Subject: Submittal of report "Effect of In-Package Chemistry on the Degradation of Vitrified High-Level Radioactive Waste and Spent Nuclear Fuel Cladding" (CNWRA 2002-01), Intermediate Milestone 01402.571.180

RESPONSES TO NRC COMMENTS ON IM 01402.571.180

“EFFECT OF IN-PACKAGE CHEMISTRY ON THE DEGRADATION OF VITRIFIED HIGH-LEVEL RADIOACTIVE WASTE AND SPENT NUCLEAR FUEL CLADDING”

Figure 2-5. Normalized Leach Rate for Boron Versus Time for WVDP Ref. 6 and DWPF Blend 1 Glasses in Various Solutions at 90 °C

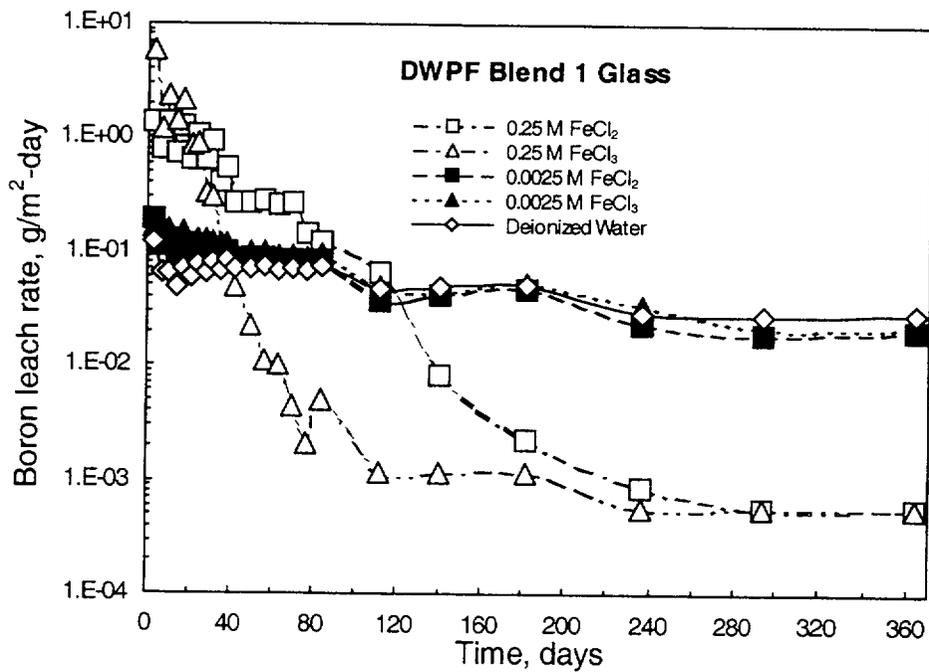
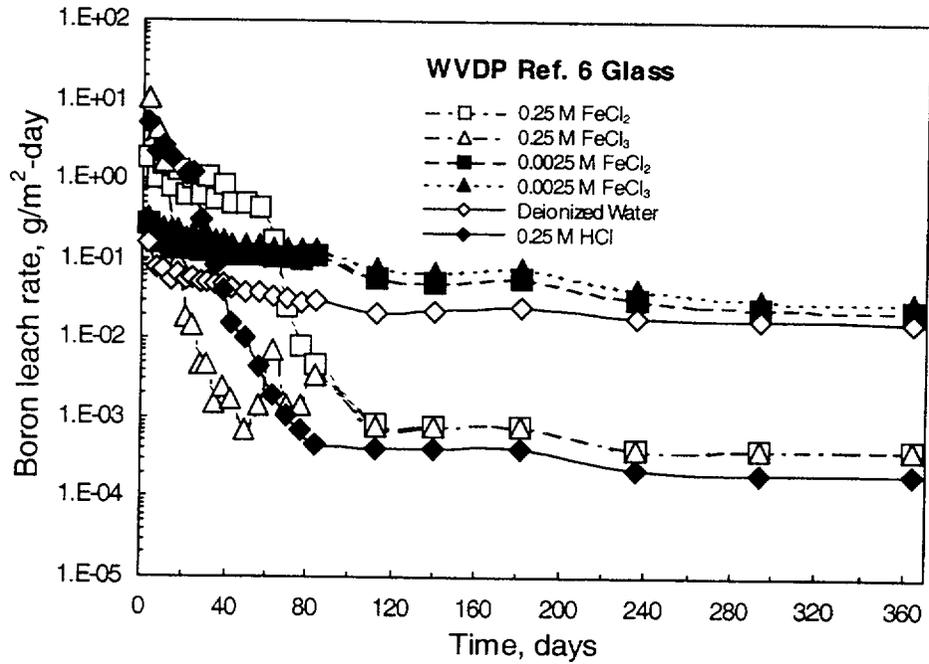
13. **Page 23, 3rd paragraph. "This theory is supported by....in Figure 2-5." Could not find the inductively coupled plasma atomic emission spectrometry analyses results in the figures.**

The boron leach rates plotted in Figure 2-5 are from the inductively coupled plasma atomic emission spectrometry analyses. No change made.

Figure 2-6. Normalized Leach Rates for Various Elements as a Function of Time for WVDP Ref. 6 Glass in 0.25 M FeCl₃ Solution at 90 °C

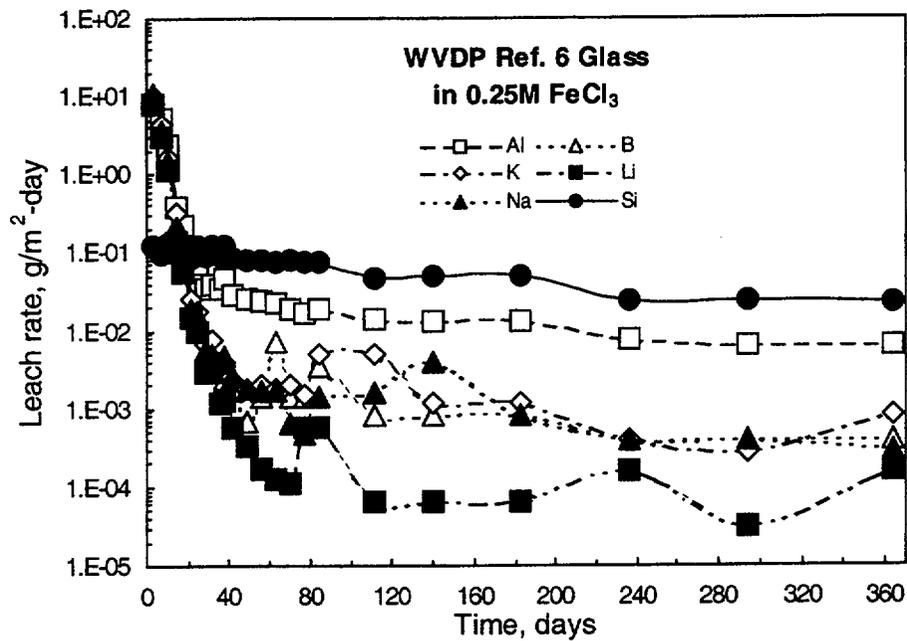
14. **Page 23, 3rd paragraph. "In the case of glass dissolution...(Figures 2-5 and 2-7)." Is the paper referring to Figure 2-6 instead of 2-5?**

Figure 2-7. Leachate pH Versus Time for WVDP Ref. 6 Glass in Various Solutions at 90 °C (Closed Symbols for the Initial pH and Open Symbols for the Final pH)

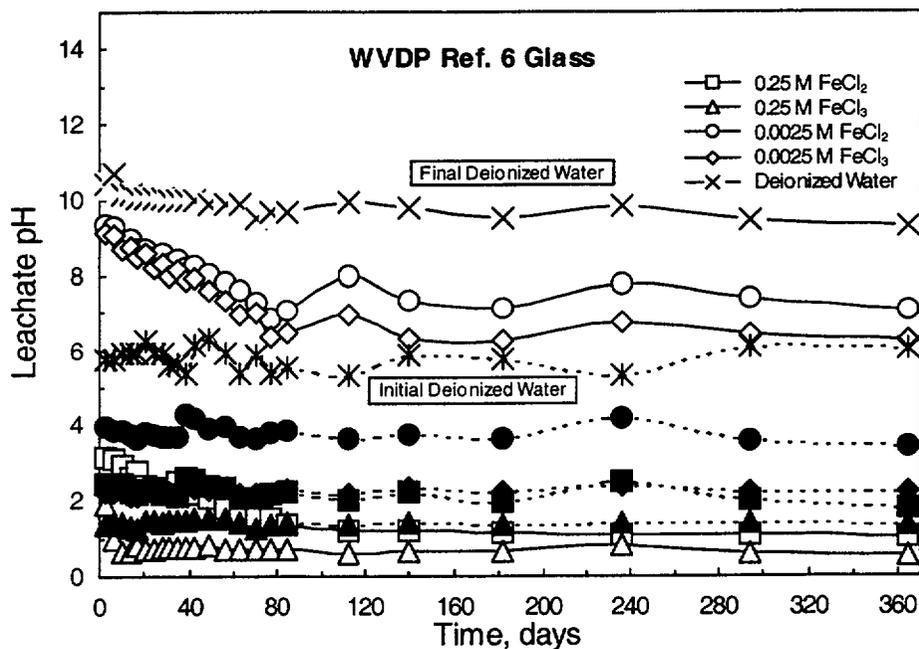
12. **Page 18, 3rd paragraph. "In all cases, except the leachates..." In figure 2-7, it appears (this is a copy and I don't have the data set) that the final pH levels are lower than the initial pH levels.**

From the glass leaching tests, the final pH values of the solutions are generally higher than the initial pH except the high concentration iron chloride solution tests. Text modified.
